**KNOXVILLE HISTORIC ZONING COMMISSION
STAFF REPORT - CERTIFICATE OF APPROPRIATENESS APPLICATION**

PROPERTY ADDRESS: 26 Market Sq 37902

FILE NO.: 10-D-18-HZ

LEVEL OF WORK: Level II. Major addition of materials or architectural elements

RAILING TO MATCH EXISTING RAILING AT 28 MARKET SQUARE

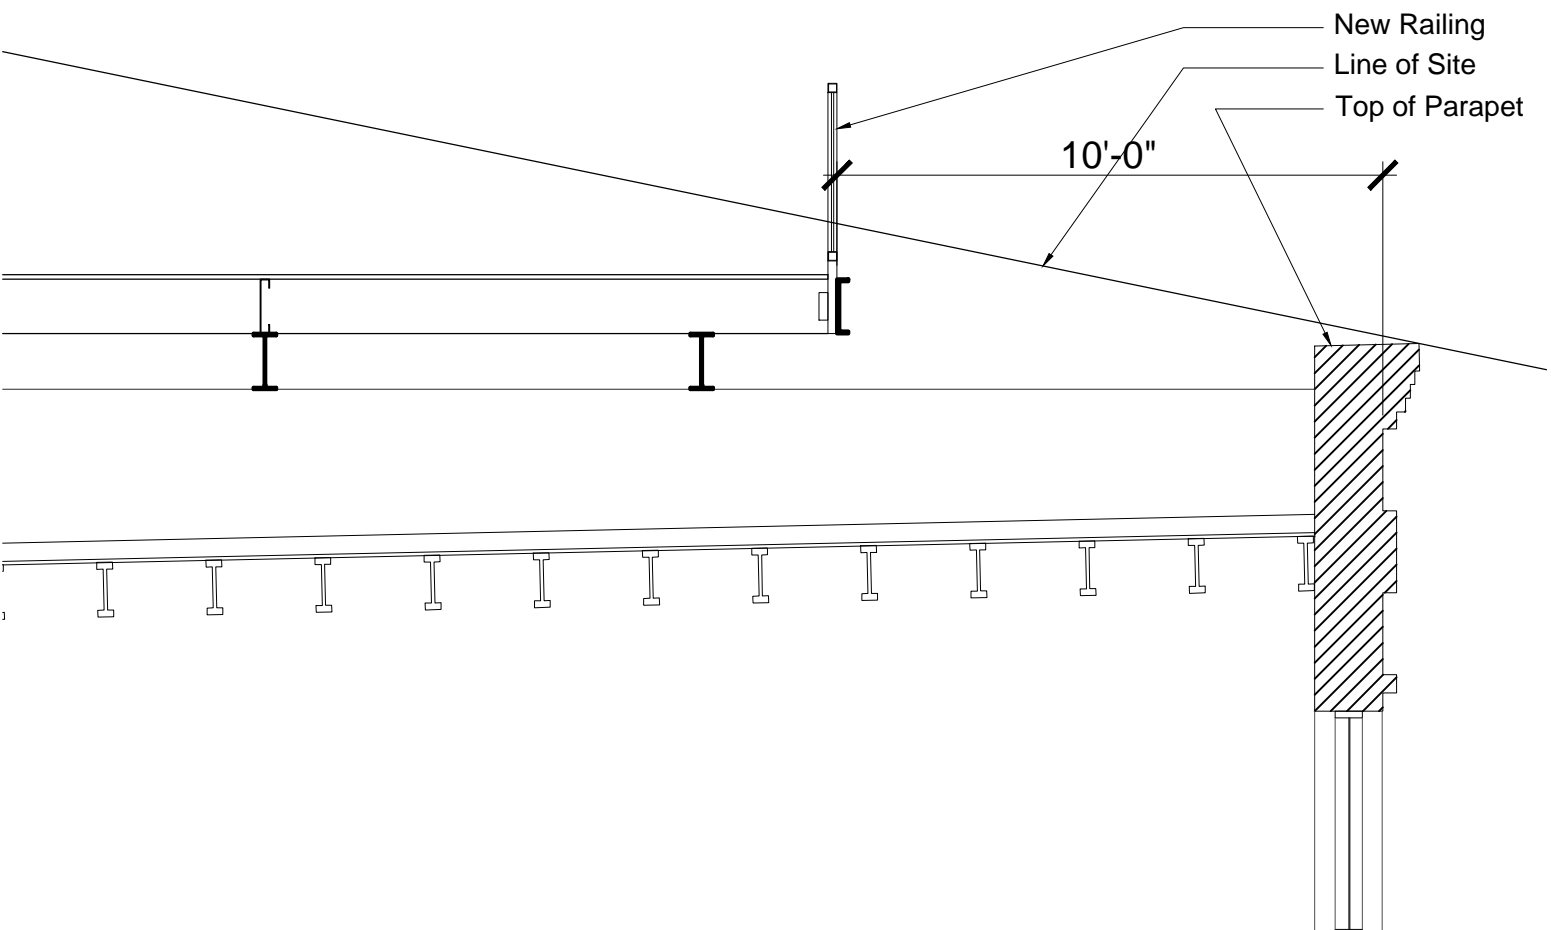
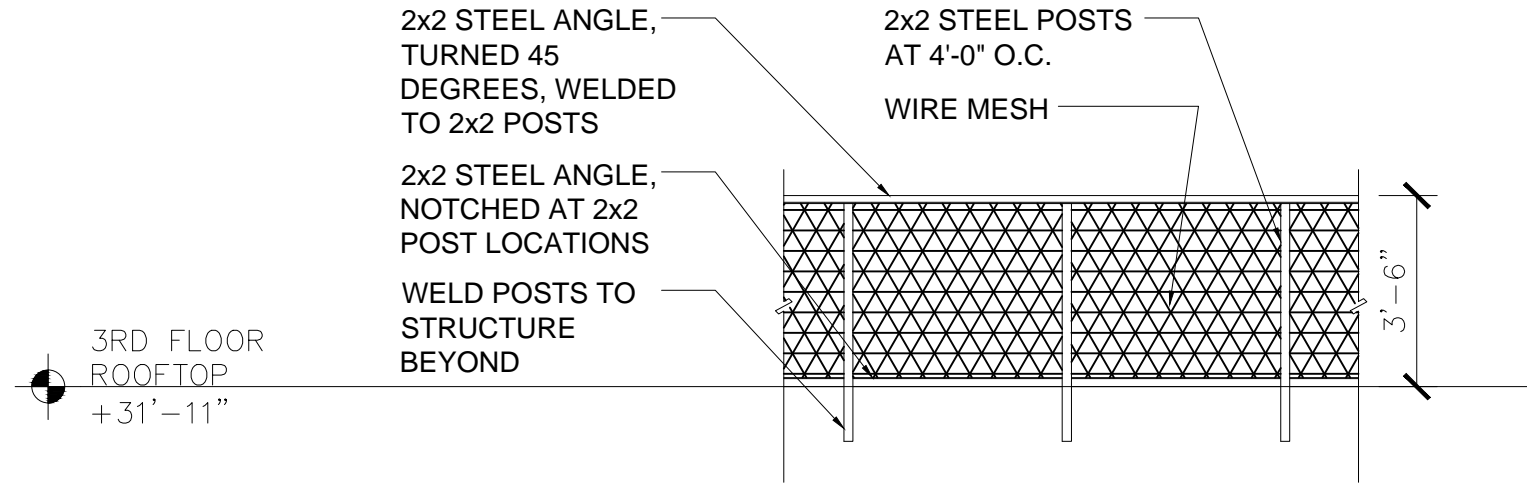
- 4) The top portion of the proposed guard railing for 26 Market Square will be visible above the top of the building's parapet from the opposite side of the Market Square public way when viewed from directly in front of the building (from 25-27 Market Square).

- 6) The proposed mesh material is practically opaque as opposed to the type of guardrails previously approved on rooftops in Market Square, and would therefore be more obtrusive.

- 7) The proposed guard rail is to match that at the adjacent north 28 Market Square. The appearance of the guardrail for 28 Market Square was not specifically reviewed since it was not approved to have any visibility from Market Square.

Staff recommend approval of a guardrail with the following conditions based on precedent and the Secretary of Interiors Standards:

- 1) that the guard railing for 26 Market Square be set at a distance back from the front roof edge so as not to be visible at any distance from within the Market Square public way when the roof edge is viewed from directly in front of the building; and
- 2) that the material and/or design be as low profile and as transparent as previously approved roof guard rails within Market Square.
